APPLICATION NO.	FILING DATE	FIRST NAMED INVENTOR	ATTORNEY DOCKET NO.	CONFIRMATION NO.
09/837,072	04/18/2001	Viktor Brost	655.00955	8832

Office Action Summary

DETAILED ACTION

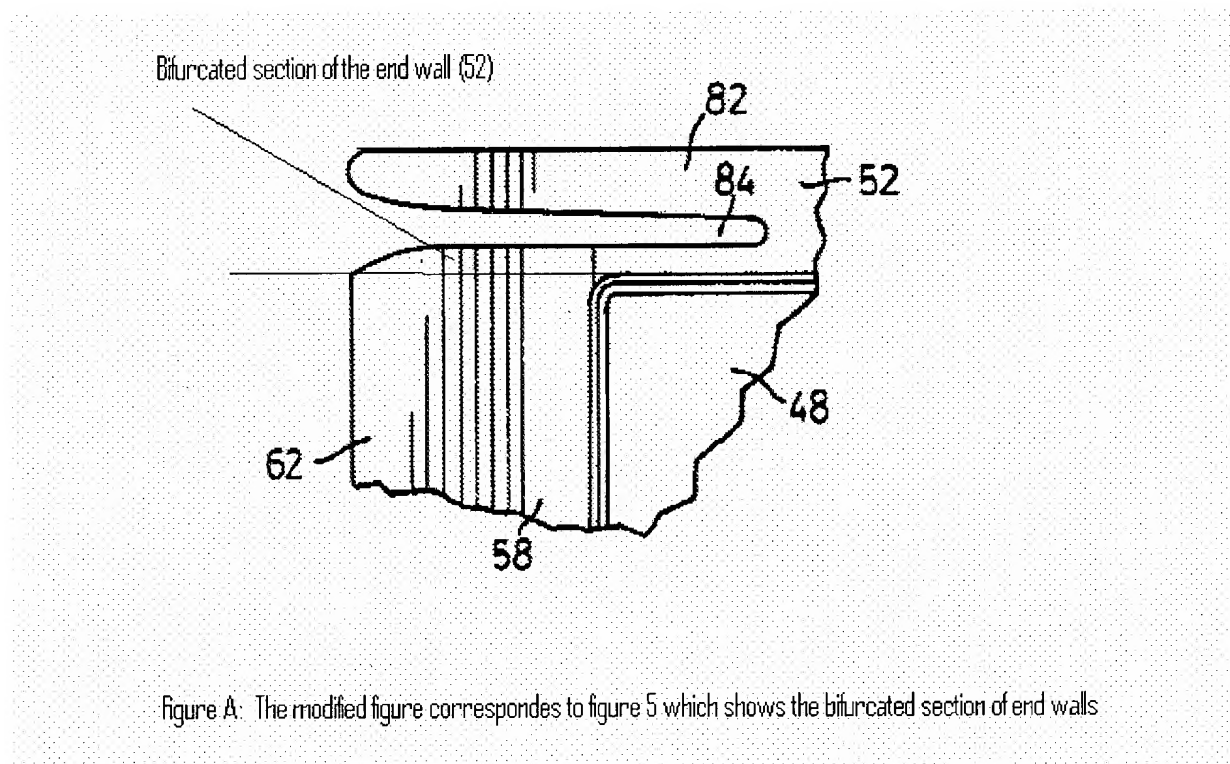
Applicant's arguments filed 11/2003 have been fully considered but they are not persuasive. Applicant's argument that Jamison's tubes are not generally rectangular because of the side flanges, has been very carefully considered but is not deemed to be persuasive. One of ordinary skill in the art would see that the tube (20), which is shown in figures 1-4 in reference to Jamison, has a generally rectangular shape (emphasizes added) since the tube (20) has 4 sides that are about perpendicular to one another. The flanges (50,52) constitute a longer side of the tube. Furthermore, applicant argues that the collecting tank (26,72) of Jamison does not abut the end walls of a tube, rather it contact the thickness of the plates within the slot. In response to applicant's argument that the reference fails to show certain features of applicant's invention, it is noted that the features upon which applicant relies (i.e., tank abut the end walls) are not recited in the rejected claim(s). Although the claims are interpreted in light of the specification, limitations from the specification are not read into the claims. See *In re Van Geuns*, 988 F.2d 1181, 26 USPQ2d 1057 (Fed. Cir. 1993). Applicant claims that the collecting tank is joined in a fluid tight manner to the end walls (claims 1 and 11) but not necessary in abut contact. Moreover, Jamison clearly discloses (figures 4, 5 and A as bellow) that the tank (72) contacts with the slots (84) of the end wall section (52) in a fluid tight manner so that no fluid escapes from the

connection between the tank and the tube. Therefore, the tank (72) is obviously joined in fluid tight manner with the end wall since the wall, which forms the slot, is the end wall section.

Though the applicant refers the elements (50,52) as a flanges in his argument, the examiner still considers to read the flanges (50,52) as the end walls since the examiner must interpret the claim as broadly as the terms reasonably allow.

Claims 1, 2 and 11 are rejected under 35 U.S.C. 102(e) as being anticipated by Jamison et al. (US 6,311,768). Jamison discloses (figures 1,7, 8 and figure A above) a radiator core comprising a radiator core (18) defining a front and a rear face thereof and including a plurality of generally rectangular shaped tubes (20) interleaved with layers of fins (22); a collecting tank (26,72) attached to the core in a fluid tight manner to provide fluid communication between the tube (20) and the collecting tank; the tubes each having a pair of side walls (48,62) extending through the core and joined by end walls (50,52) at the front and rear faces of the core. Jamison further discloses (figure 8) that the tubes (20) each terminating at one end thereof in a formed segment wherein the end walls (50,52) of each tube are bifurcated for a distance from one end of the tube and at least one of the side walls (62) is directed away from the other side wall to be adapted to contact a side wall of an adjacent tube in the core; the directed side wall (62) being joined in a fluid tight manner to the contacted side wall of the adjacent tube (by brazing). Jamison further discloses (figure 7) that each collecting tank (26) having walls (70,72) extending over the front and rear faces of the core past bifurcation of the end walls, which start at portion (58), and joined in a fluid tight manner to the end walls of the tubes at a portion (100) along and beyond the bifurcation.
